TOWN OF CARMEL
PLANNING BOARD

PLANNING BOARD AGENDA
DECEMBER 9, 2015 – 7:00 P.M.

RE: PCSB Site Plan
Route 6
Tax Map No. 86.11-1-1 – Proposed Lot 1

RE: Route 6 Retail Site Plan
Route 6
Tax Map No. 86.11-1-1 – Proposed Lot 2

SHEET: SP-1/7

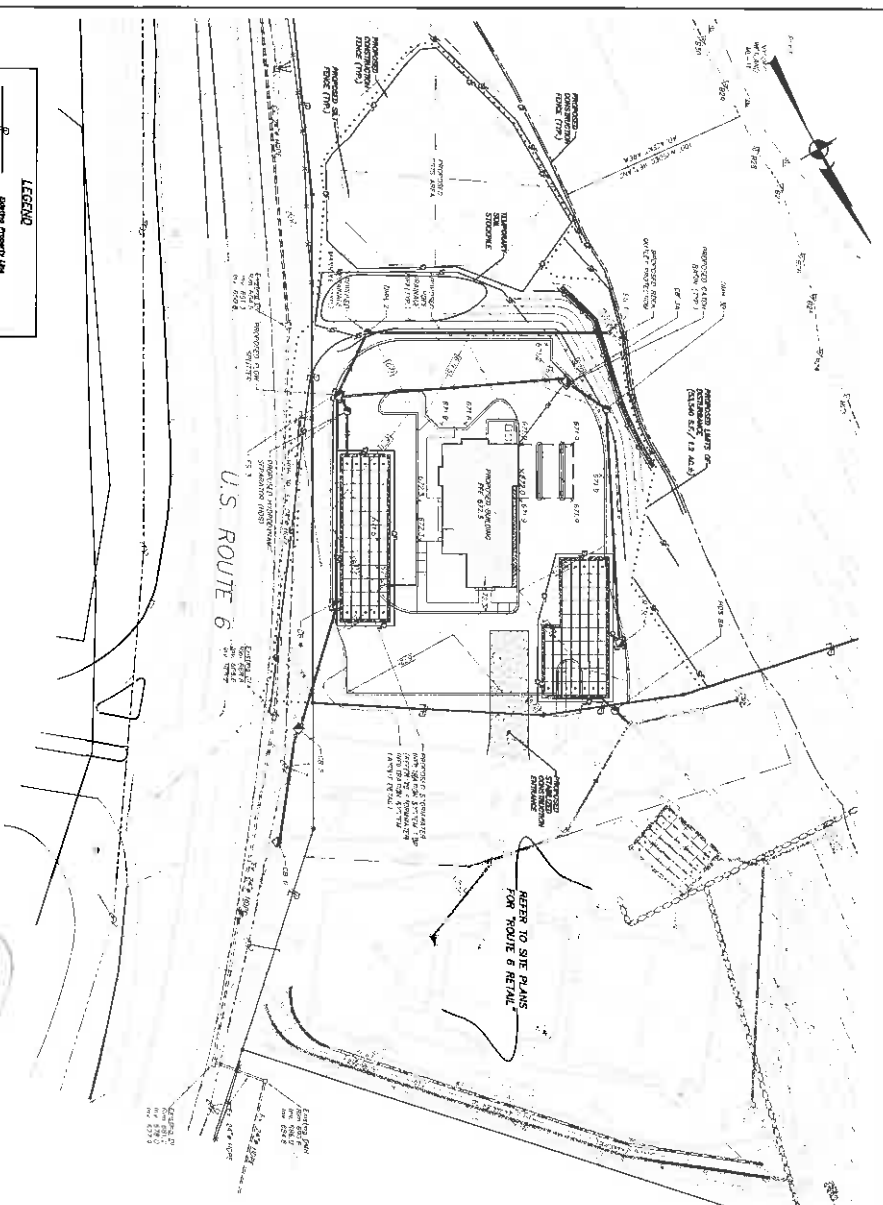
2. Layout and Landscape Plan – SP-1
 3. The easements for site access, SMPs and utilities are shown on the plan. Agreements/easements will be provided in a later submission.

- a. It is understood that all plantings should be verified by the Town of Carmel Wetlands Inspector.
 - b. The trees that are specified on the plan meet the requirements of Section 142 of the Code. In addition, a note has been added to the General Planting Notes on Drawing SP-1 stating that all plantings shall be installed per Section 142 of the Town of Carmel Code.

- c. The traffic signal has been labelled as proposed on the site plan.
 - d. A lighting photometric plan has been provided in this submission.
 - e. The legend has been updated to identify the proposed pole-mounted light symbol.

A-2.1

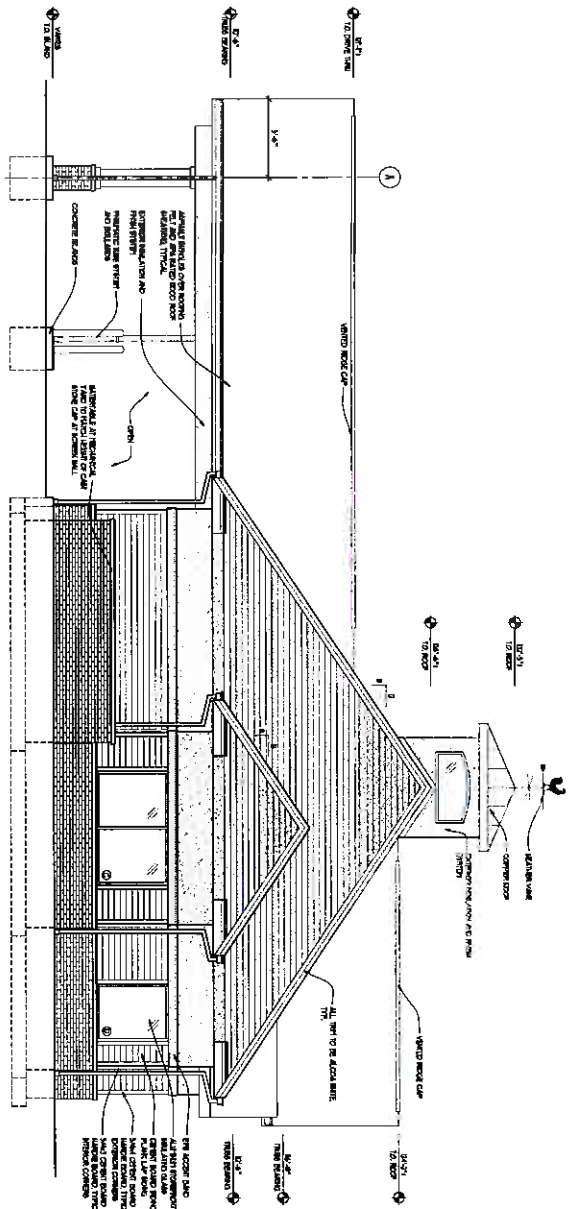
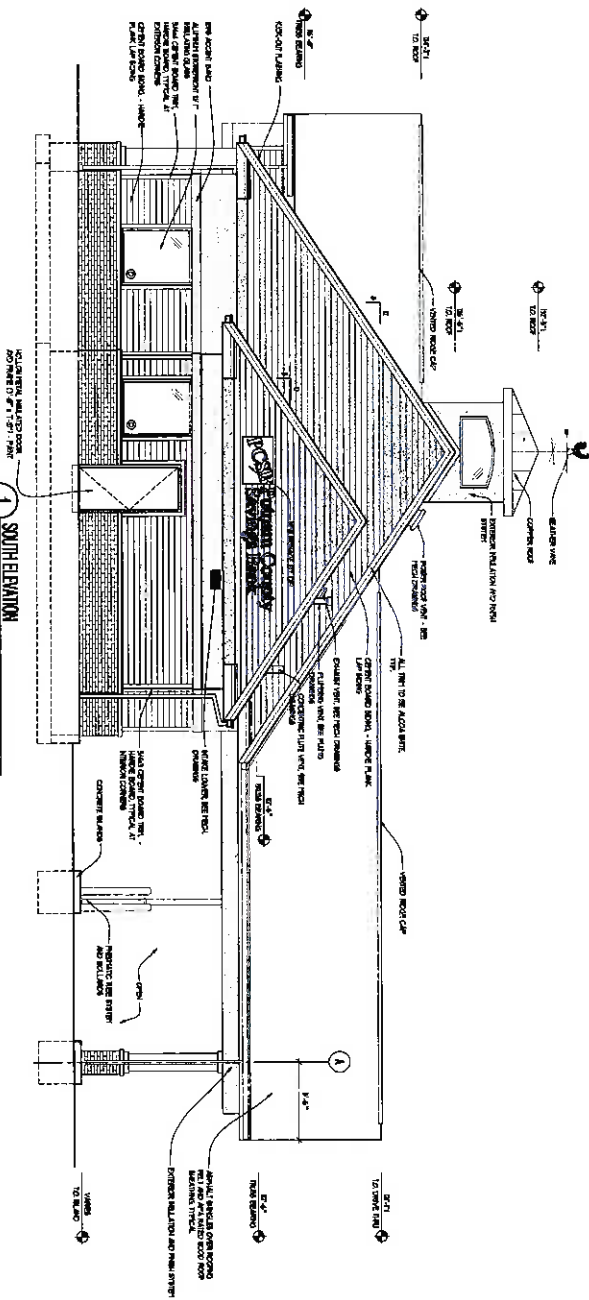
10. See response # 9 above.
11. The applicant has added mullions to the windows at the request of the Planning Board. Refer to the colored building elevations included in this submission.

12. Some of the mechanical equipment must be located outside the building. A screened mechanical yard has been added to the south side of the building. This is shown on the site plans, as well as the building elevations.

OVERALL PLAN

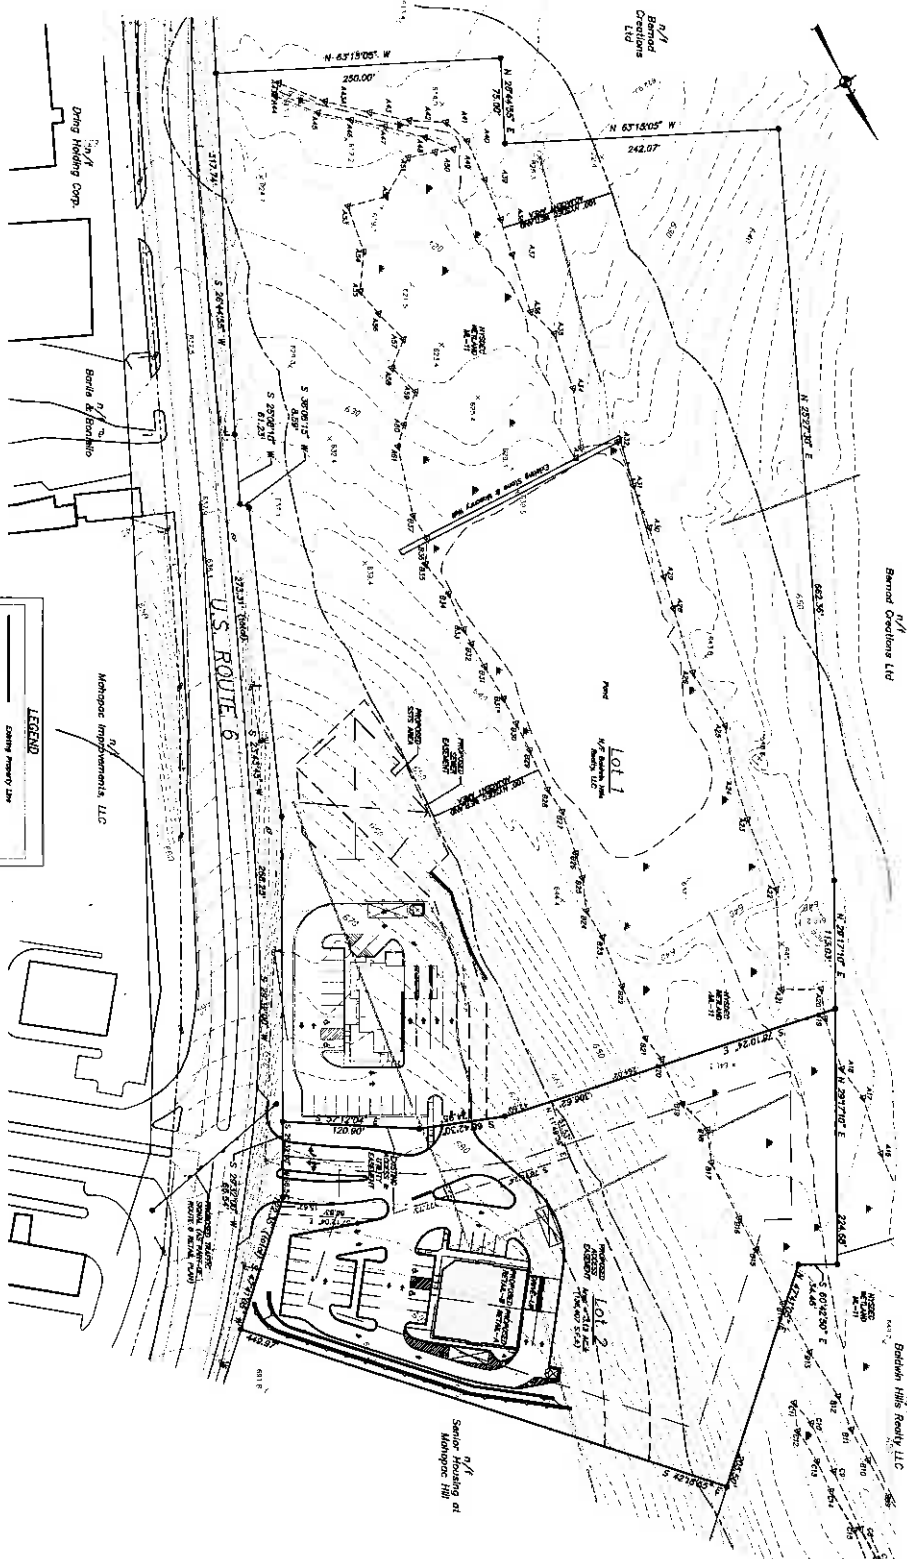
1. Overall Plan – OP-1
 - a. Maser Consulting is working with the NYSDOT relative to the Route 6 traffic improvements associated with the entrance to the project. Should available sight distances be required to be evaluated as part of the proposed traffic improvements, these will be established and reviewed by the NYSDOT. Should any clearing along the edge of the roadway right of way be necessary to assure appropriate sight distances are provided, it will be added to the site plans.

LAYOUT & LANDSCAPE PLAN

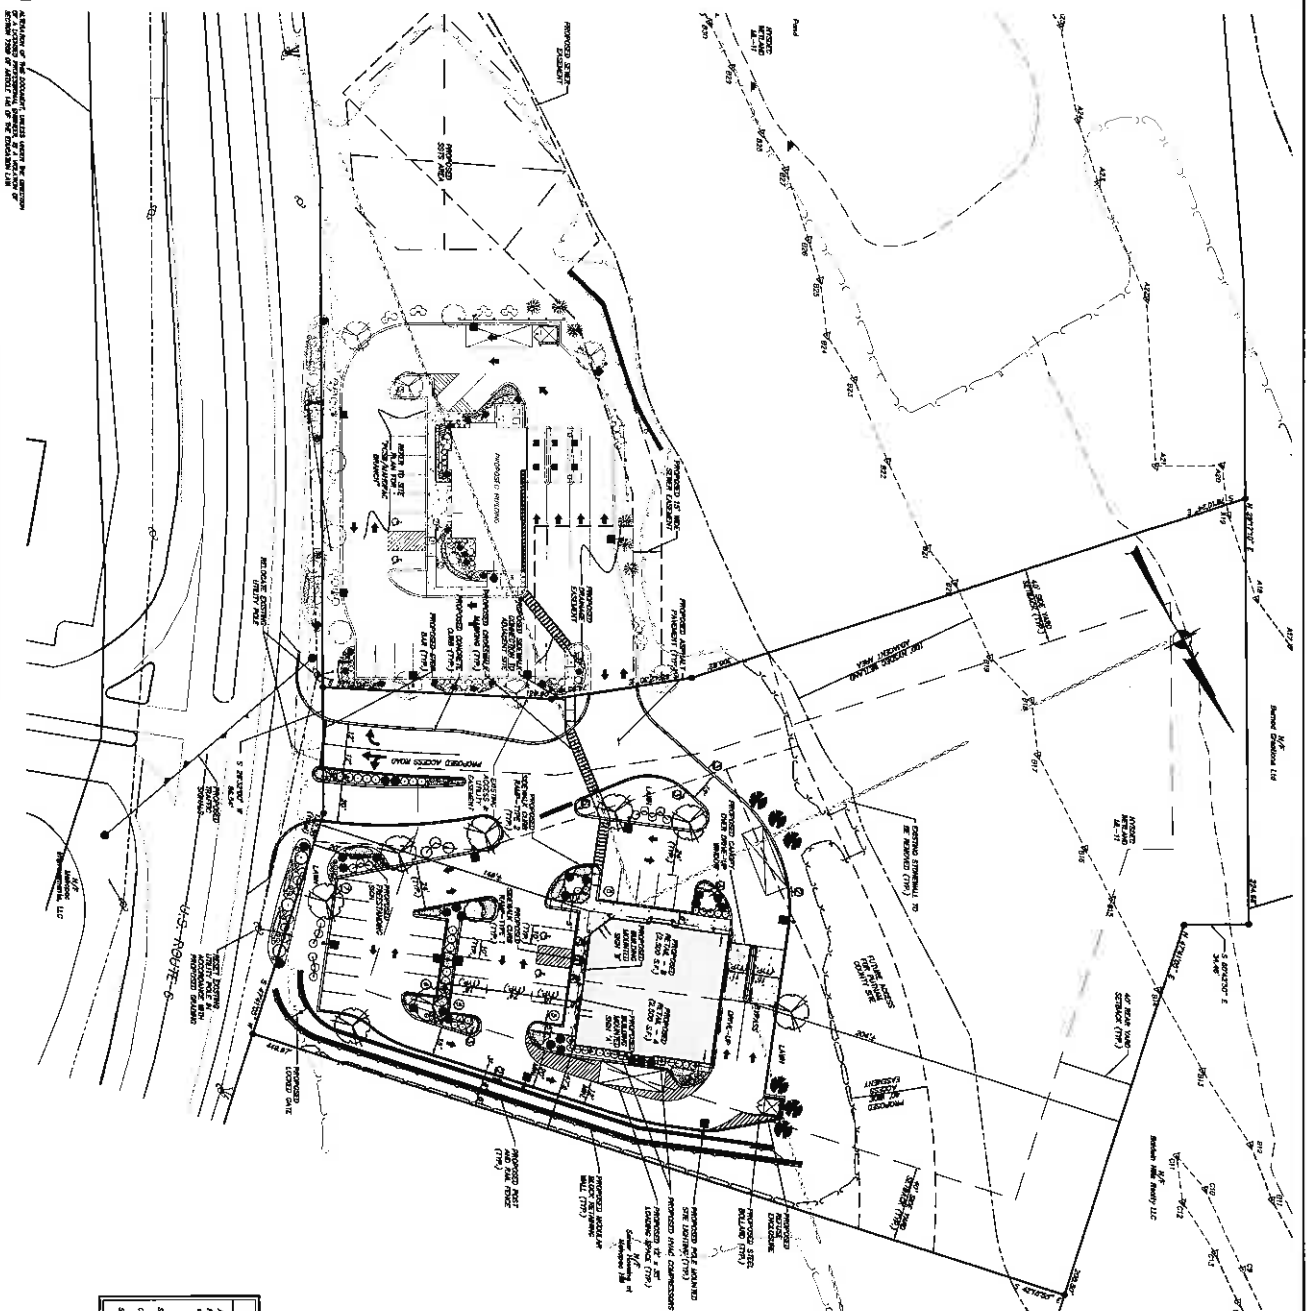
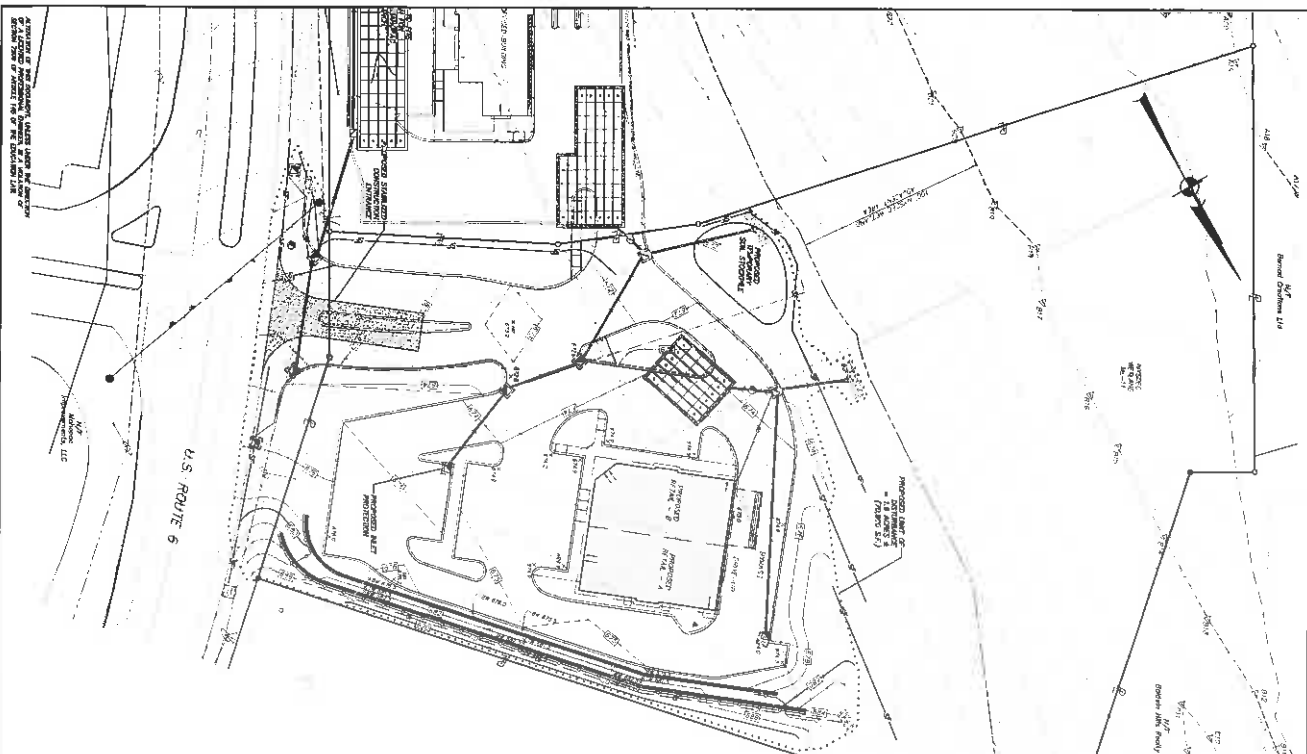
- b. The traffic signal is labelled as proposed on the plan.
2. Layout and Landscape Plan – SP-1
 - a. The easements for site access, SMPs and utilities are shown on the plan. Agreements/easements will be provided in a later submission.

- b. It is understood that all plantings should be verified by the Town of Carmel Wetlands Inspector.
 - c. The trees that are specified on the plan meet the requirements of Section 142 of the Code. In addition, a note has been added to the General Planting Notes on Drawing SP-1 stating that all plantings shall be installed per Section 142 of the Town of Carmel Code.

- d. A lighting photometric plan has been provided in this submission.
 - e. Wind load calculations would be provided as part of the building permit review.

DRAWING:
AERIAL VICINITY MAP

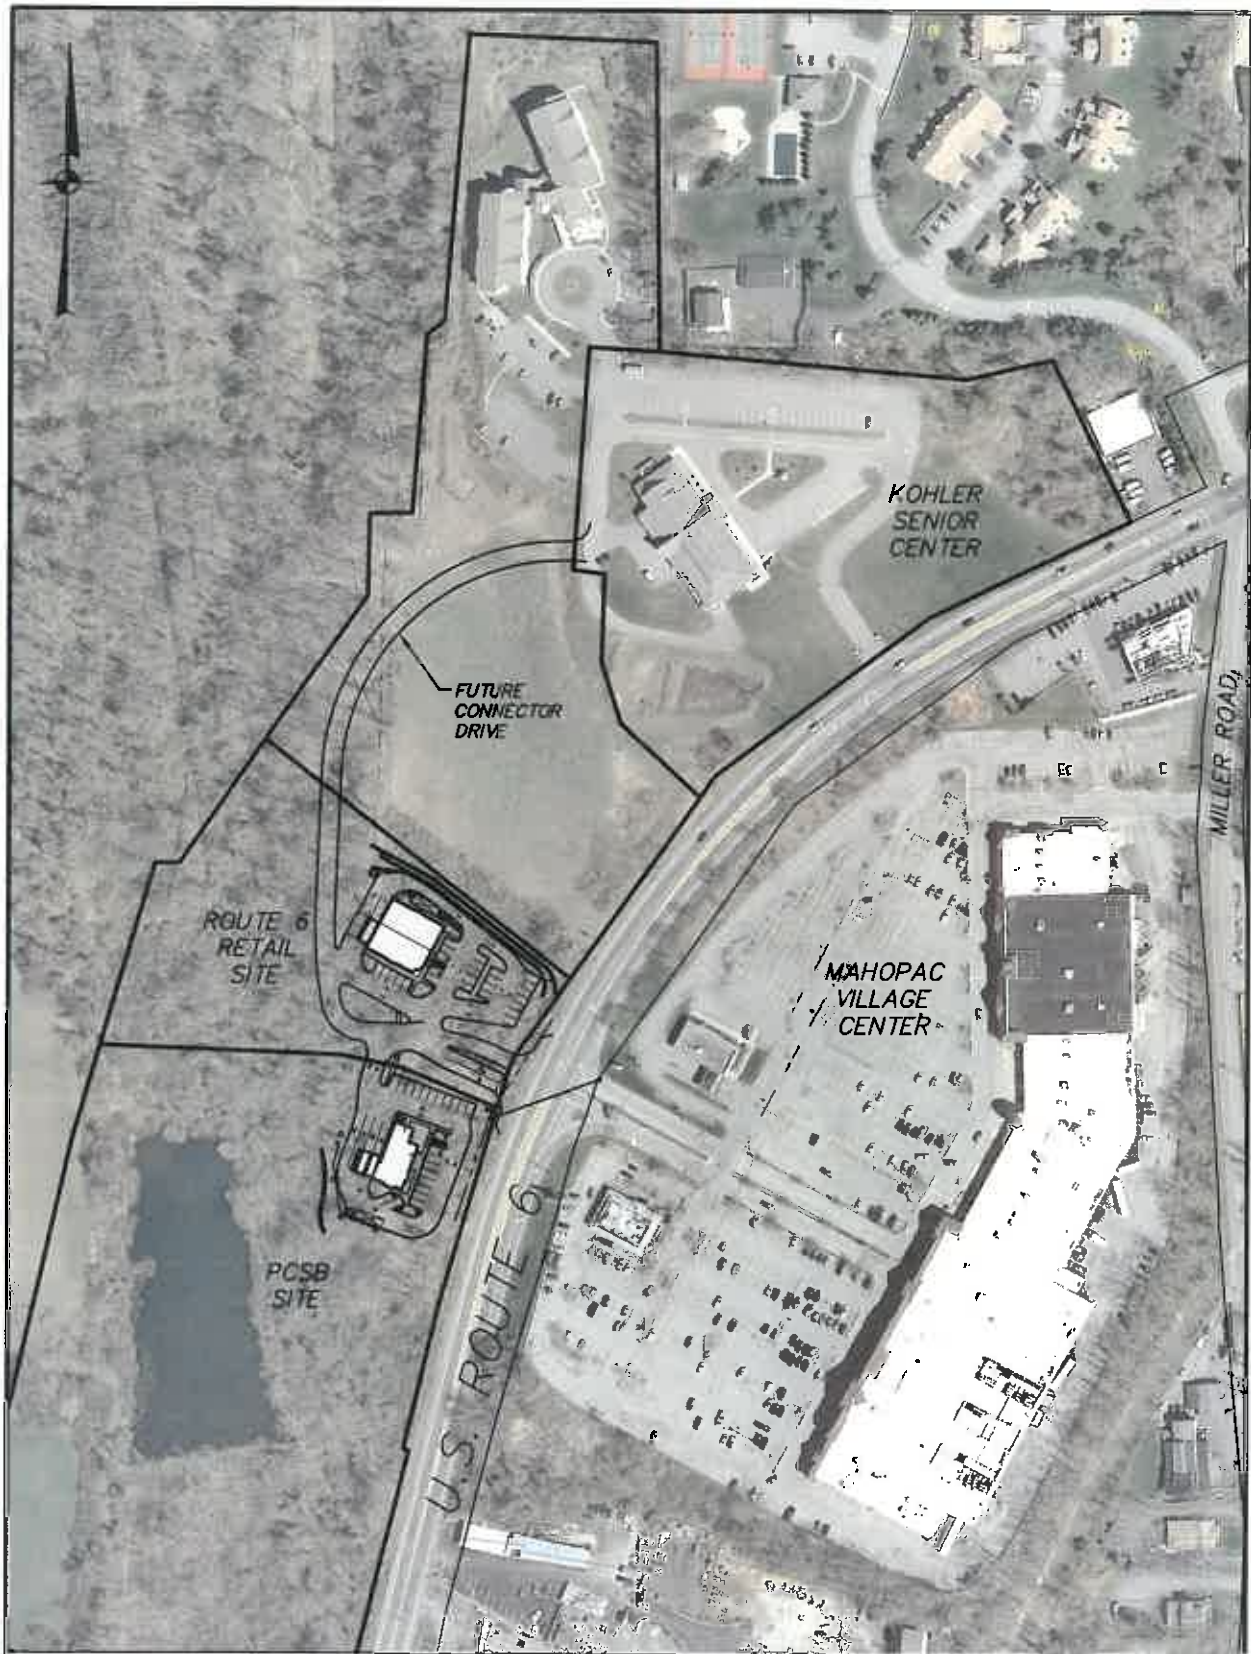
1. Color renderings of the building elevations have been included in this submission.
2. An aerial vicinity map is included in this submission to show how the site relates to the Kohler Senior Center on the adjacent site to the north.
3. A grading study sketch for the future connector drive to the Kohler Senior Center has been included as part of this submission.
4. The traffic study has been amended to include consideration of the Kohler Senior Center.
5. At the recommendation of the Planning Board, the project was presented informally to the Environmental Conservation Board in consideration of a future application for a wetland permit. Since that time, the

8. The proposed location of the future connector drive to the Kohler Senior Center has been analyzed. An aerial map depicting the relationship between the two sites, as well as a conceptual grading plan for the connector drive have been included as part of this submission.
